The Water House

Executive Summary

Comments on RSK's response to the Independent Review of the BIA

ASSUMED SECTION.

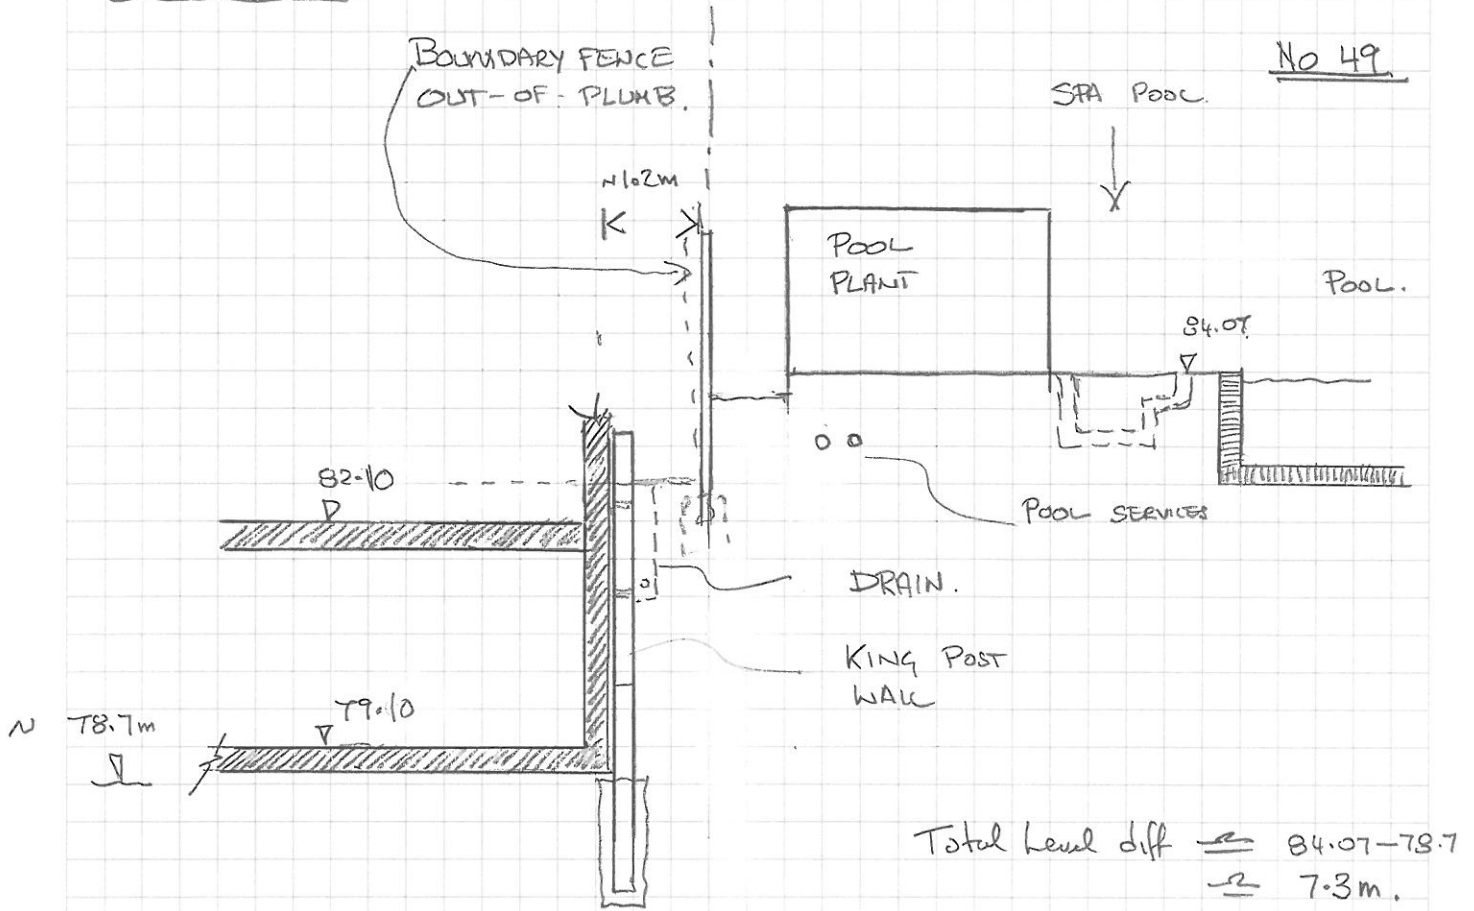
The principles of constructing a king post wall are fully understood, and it is an acceptable approach in areas away from existing buildings or sensitive structures. As noted above the concerns relate to the use of this type of construction close to the site boundary where there is a significant level difference, a pool plant room, a spa pool, pool drainage services and a boundary structure which is already out of plumb – see SKA-A for the typical assumed section. This needs to be fully surveyed so that the accurate sections can be drawn and considered.

- a) There will be a 2-3m length of unsupported excavation before the concrete panel can be inserted. Also, in order to enable this to be pushed in, there will probably be a minimum of 25mm over excavation of soil on average.
- b) Due to the proximity of the boundary structure and the change in level across the boundary, the boundary structure will move significantly.
- c) Due to the gaps behind the precast concrete panels the ground movements will be much more than predicted by the analysis.

In our opinion a king post wall and drain in this location will cause significant damage to the boundary structure and potentially the pool plant room and spa pool. It is likely the impact on the swimming pool has been under-estimated.
